APPLICATION FOR IMPROVEMENT PERMIT
FOR RESIDENTIAL SITE
INDIVIDUAL WATER AND WASTEWATER
SYSTEMS PROGRAM

ON-SITE WASTEWATER SECTION
2277-B

SOIL/SITE EVALUATION for ON-SITE WASTEWATER SYSTEM

Re: Black Farm Road, Lot 4
File: ~~2274B~~ 22725
Parcel: 011-052-04PO

PROPOSED PLOT PLAN

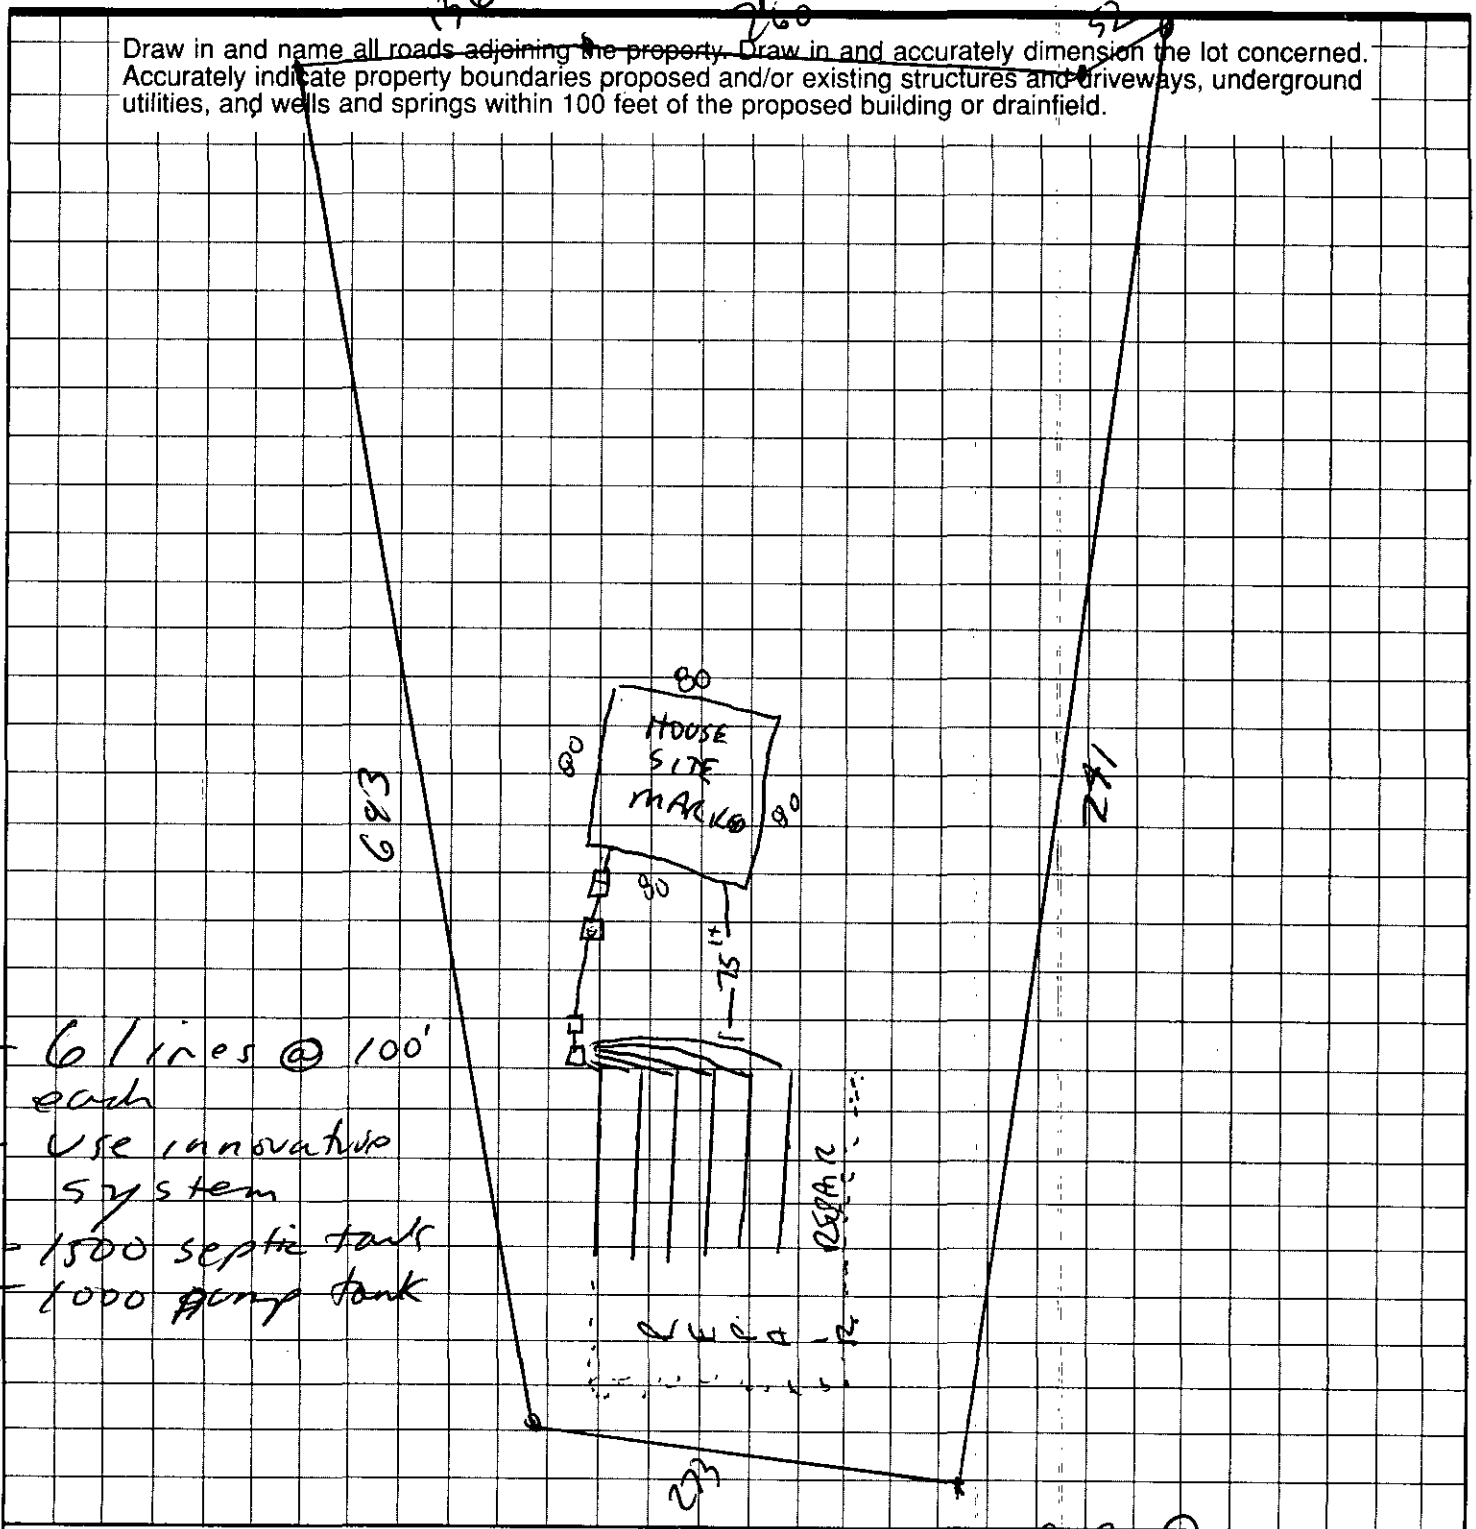
- 6 lines @ 100' each
- Use innovative system
- 1500 septic tank
- 1000 pump tank
